Wright & Dalbin Architects, Inc.

BID #10-024, CONSTRUCTION IMPROVEMENTS FOR THE JUVENILE JUSTICE CENTER EL PASO, TEXAS

ADDENDUM NUMBER FIVE

May 13, 2010

AC-104 SHEET OF

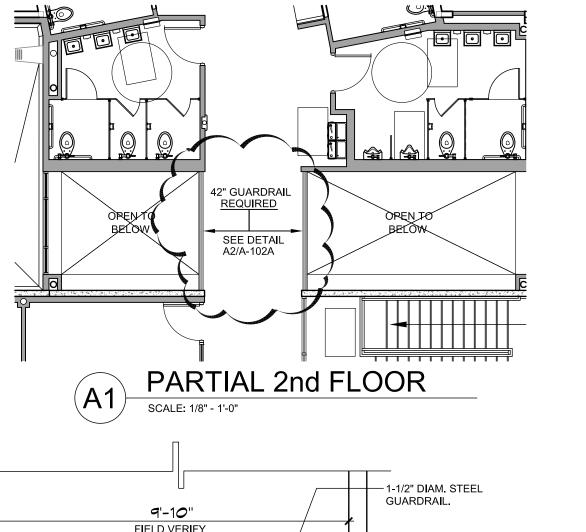
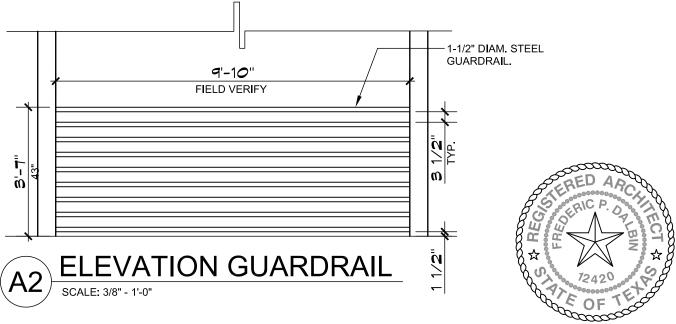
- 1. Architectural:
 - A. <u>Sheet AC-104 Temporary Construction Site Control Plan</u>: Add sheet provided with this addendum.
 - B. <u>Sheet A-102A- Partial 2nd Floor / Guardrail Detail</u>: Add sheet provided with this addendum.
 - C. <u>Sheet A402 Enlarge Floor Plans Sections And Details</u> Add Elevator Waterproofing detail Sheet A402A provided with this addendum.
 - D. <u>Sheet A-403 Courtroom Enlarged Floor Plan and Interior Elevations</u>: Add sheet provided with this addendum.
 - E. <u>Sheet H-101 Demolition Plan</u>: Replace sheet with H-101R with provided with this addendum.

A= A Temporary Construction Site Control Plan (TCS Plan) is attached to this addendum. First floor of the existing building will be vacated during the construction. However, it is the intent of the County to have the majority of the second floor operational. JPD understand that some coordination will be necessary and disturbance will occur when new structure is to be tied into the existing second floor and roof or when the elevator will be removed and floor patched. Also refer to drawing H101R, provided in Addendum No. 3

A-102A
SHEET OF

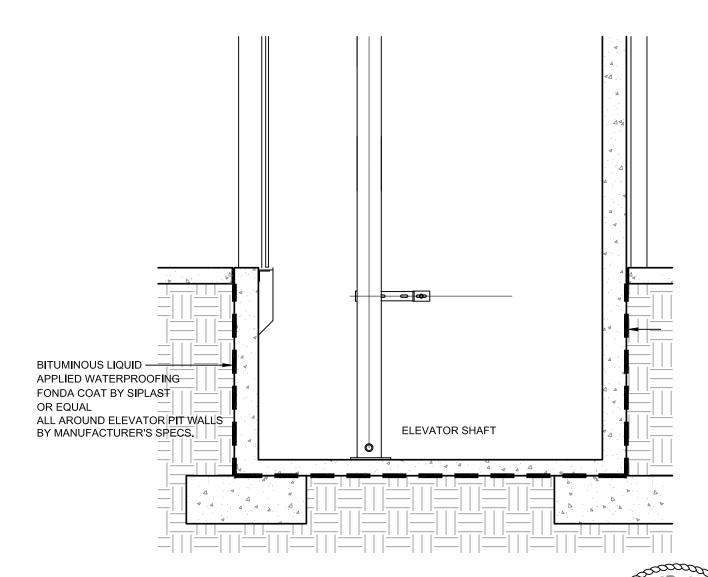
41. The two open to below areas just west of rooms 219 & 220 border along a corridor. Please indicate the type of fall protection to be constructed here. Is it to be a type of railing or a wall? Please advice.

A= It is a railing. A detail is provided in this addendum.

Al-111b

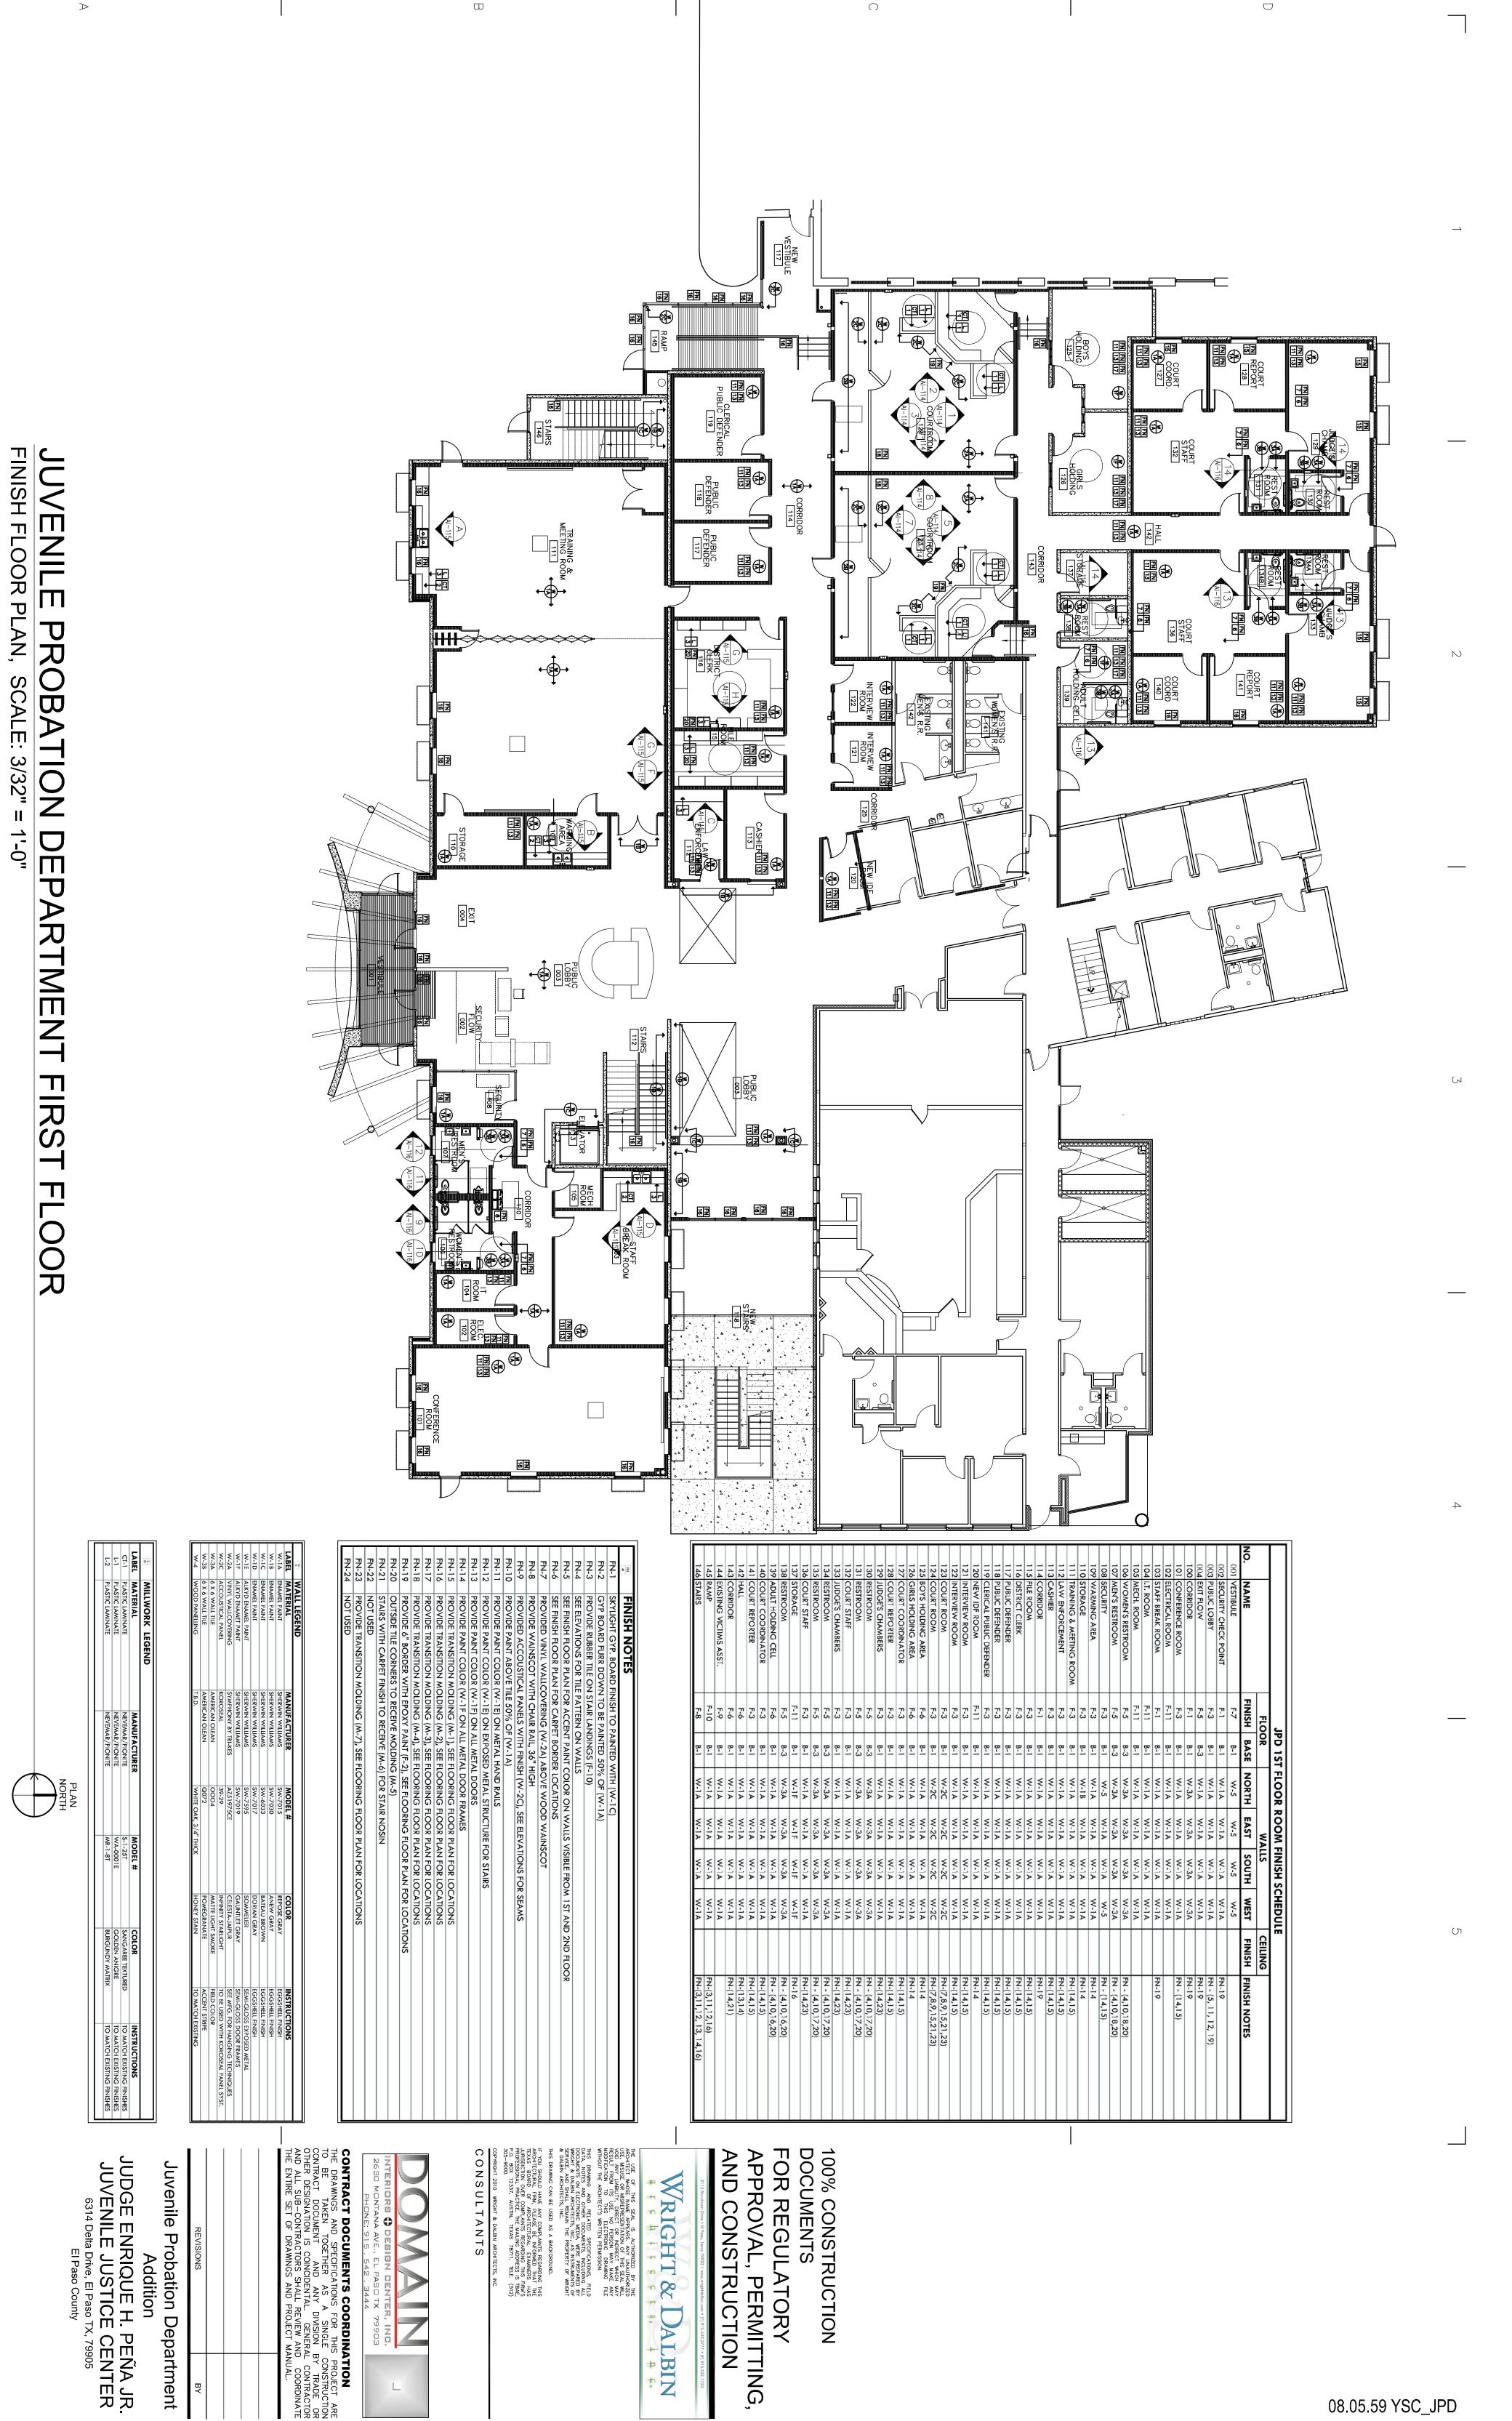
- A. Sheet Al-111A- Juvenile Probation Dept. First Floor: Add section provided with this addendum.
- B. Sheet Al-111B Juvenile Probation Dept. First Floor: Add section provided with this addendum.

SHEET C-12-B

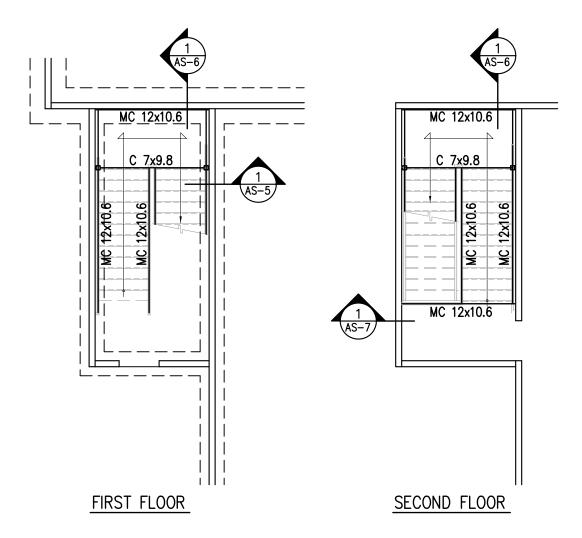
35. Please identify the finish of the drop inlet grates detailed on C-12.

A= See sheet C-12-B provided in this addendum.

AS-2

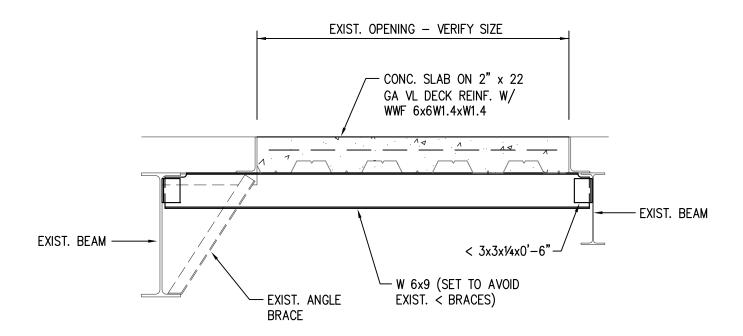
A. Add details sheets for Exit Stair Plan; Stair Detail; Concrete Landing Detail; Concrete Footing & Foundation Detail; 2nd Floor Framing Detail; Exterior Stair Plan; Main Stair Plan; Concrete Slab Detail given in Sheets AS-1 through AS-9 provided with this addendum.
